Clause 169 Power Parameters

Michael Paul

Response to Comments 150, 151 and 152

Comments 151 and 152

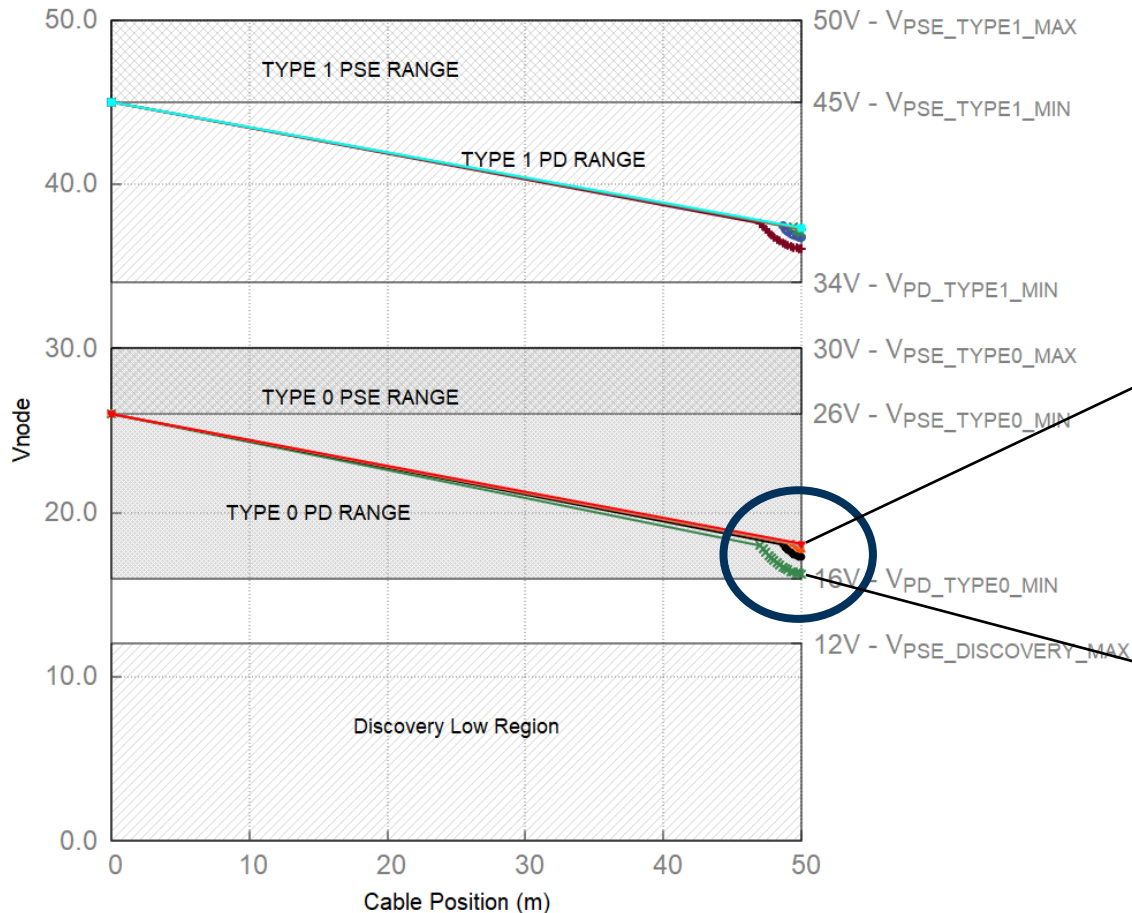
Higher unit load systems have less channel resistance

Nodes	Unit load level	Rchan (Ω)	Last MPD Voltage (V)	P _{MPSE_16U} (W)	I _{TCI_MPSE} (W)
1	16	8.94	18.10	22.998	0.885
2	8	9.18	19.94	23.118	0.889
4	4	9.58	17.74	23.282	0.895
8	2	10.38	17.29	23.673	0.911
16	1	11.98	16.28	24.660	0.948

Round to 26W

Round to 1A
